ACCESSION NBR: 9311160413 DOC.DATE: 93/11/04 NOTARIZED: NO DOCKET #
 FACIL: 50-305 Kewaunee Nuclear Power Plant, Wisconsin Public Service 05000305
 AUTH.NAME AUTHOR AFFILIATION
 SCHROCK, C.A. Wisconsin Public Service Corp.
 RECIPIENT NAME RECIPIENT AFFILIATION
 MARTIN, J.B. Region 3 (Post 820201)

SUBJECT: Amends 931103 ltr to request enforcement discretion for 168 h beyond current 72 h LCO, based on current status of repair activities associated w/RHR pump as discussed in 931104 telcon, in ref to NRC Insp Manual, Part 9900.

Docket 50-305
Operating License DPR-43
Kewaunee Nuclear Power Plant
Request for Enforcement Discretion
for Kewaunee Nuclear Power Plant

Docket 50-305
Operating License DPR-43
Kewaunee Nuclear Power Plant
Response to Notice of Violation 93-012-01

CONTROL ROOM AIR CONDITIONING

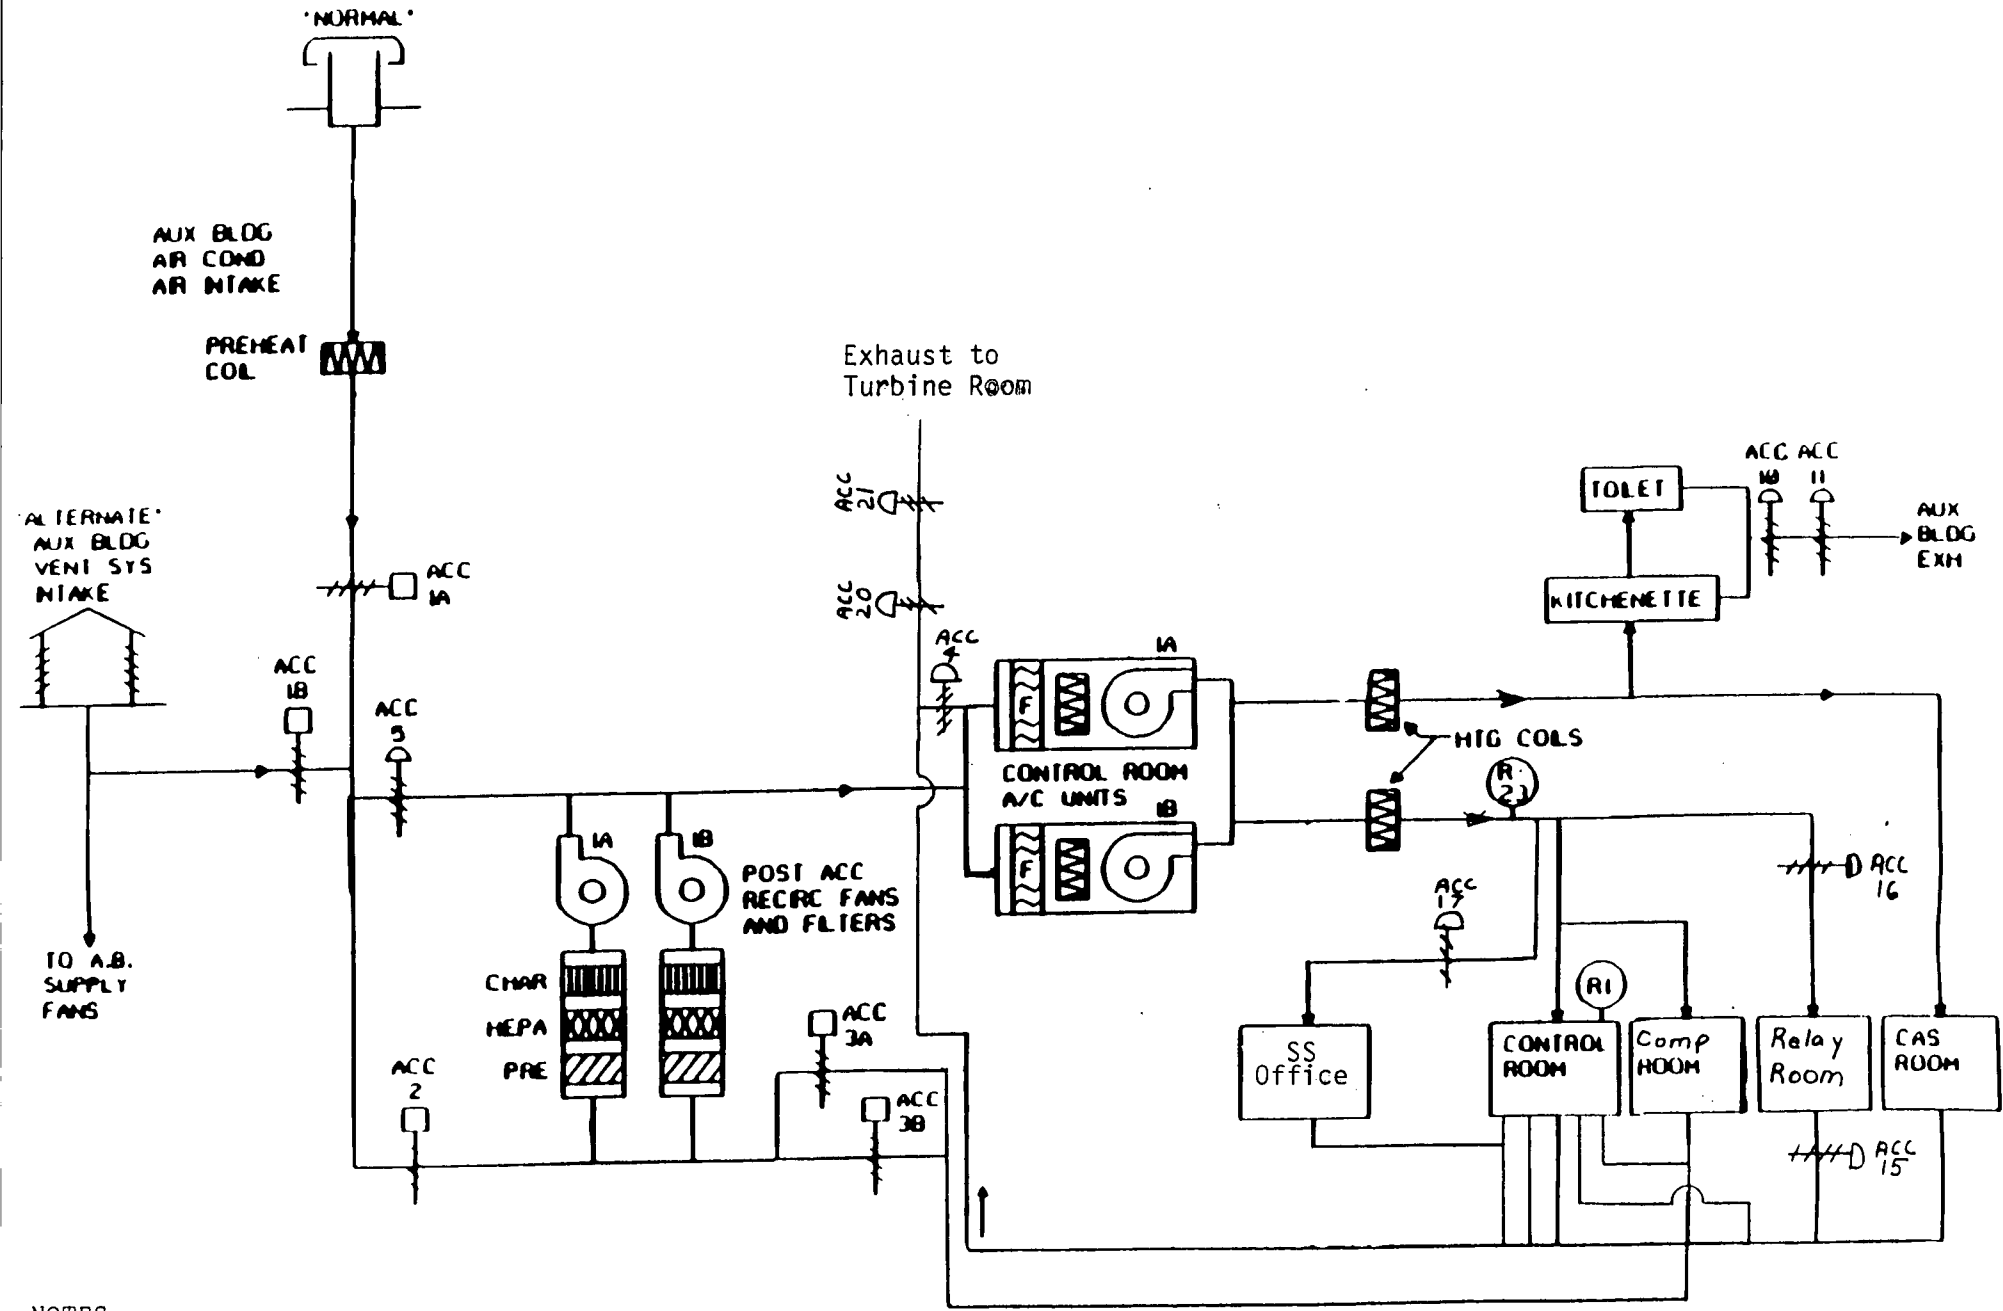
Contrary to the above, Safety Evaluation Report, Revision 0, dated March 8, 1991, for DCR 2373-2, "Control Room Post-Accident Recirculation Dampers ACC-3A & ACC-3B and Fresh Inlet Damper ACC-2," did not identify that the change created the possibility of a different type of malfunction than previously evaluated in the safety analysis report, did not adequately determine if the change involved an unreviewed safety question, and consequently did not provide an adequate bases for the determination that the change did not involve an unreviewed safety question. (305/93012-01)

Design Change Request (DCR) 2373-2 was implemented in April 1991 to remove the interlock between the fresh air inlet damper (ACC-2) and the redundant recirculation dampers (ACC-3A and ACC-3B) in the control room post-accident recirculation (CRPR) system, refer to attachment 2. Removal of the interlock prevents a single failure of ACC-2 from isolating recirculation flow through ACC-3A or ACC-3B. As noted in the inspection report, the design package for the DCR failed to provide adequate justification that the removal of the interlock did not increase the probability of bypassing the charcoal filters. Bypassing the filters would allow unfiltered contaminated air to enter the control room.

In addition to the corrective actions already taken, the USAR will be revised to reflect how the system is described in operating procedure E-ACC-25. The annual update to the USAR is currently scheduled to be submitted to the NRC in November 1994. Furthermore, DCR 2373-2 will be used as a case study in the refresher training on the performance of safety evaluations. The training is tentatively scheduled to occur during the first quarter of 1994. The training will be provided to members of the engineering staff that are typically responsible for performing safety evaluations.
